TESLA	Tesla, Inc. Service Bulletin	Inspect Front Knuckles And Front Uppe Control Arms		ront Upper
_	24-31-001 ary 4, 2024	Control Arms		
Classification		Section/Group	Mobile Service	Configuration
Campaign Bulletin		31 - Suspension	Cannot Perform	All

Model Year Model Country/Region **Build Location** 2023 **United States** Giga Austin Cybertruck The model(s) and model year(s) listed are a general approximation of the affected VIN list. Refer to the VIN/Bulletin Tracker or Customer/Vehicle profile to determine applicability of this bulletin for a particular vehicle.

Figure 1

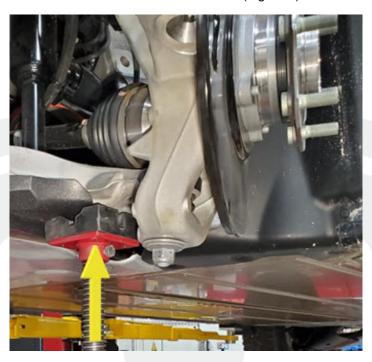
- 1. Remove both front wheels (refer to Service Manual procedure 34015001).
- 2. Raise the vehicle to the proper working height, and then engage the safety locks on the 2 post lift (refer to the Service Manual <u>procedure</u>).
- 3. Support the LH front lower control arm with the underhoist stand (Figure 1).
